## Determination 2013/001<sup>1</sup>

# Regarding the issuing of a building consent for the separation of surface water drainage to 39 and 39A Towai Street, Kohimarama, Auckland

Figure 1: site plan (not to scale)

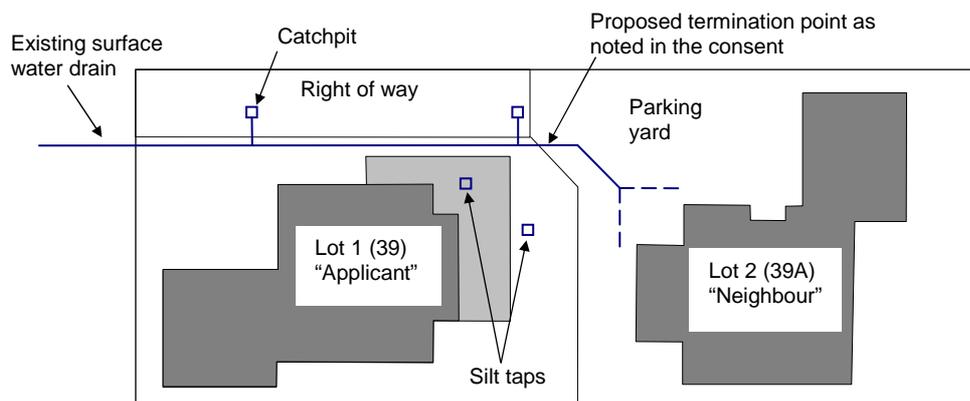
2.2 The site is essentially flat, with nominal fall from the property to the street (to the left of Figure 1).

2.3 In addition to the discharge from the roofs of both townhouses, the existing surface water drain collects surface water from the parking yard and the driveway for Lot 2, via two catchpits located within the right of way, and surface water via two silt traps.

2.4 The shared section of the surface water drain crosses Lot 1.

2.5 Lot 2 has a right of way and power, telephone, water and supply of gas rights over a designated part of Lot 1. The surface water from the parking yard to Lot 2 runs to two catchpits in the right of way which, in turn, are connected to the surface water drain to Lot 1. No part of the surface water drain used by Lot 2 is within the right of way.
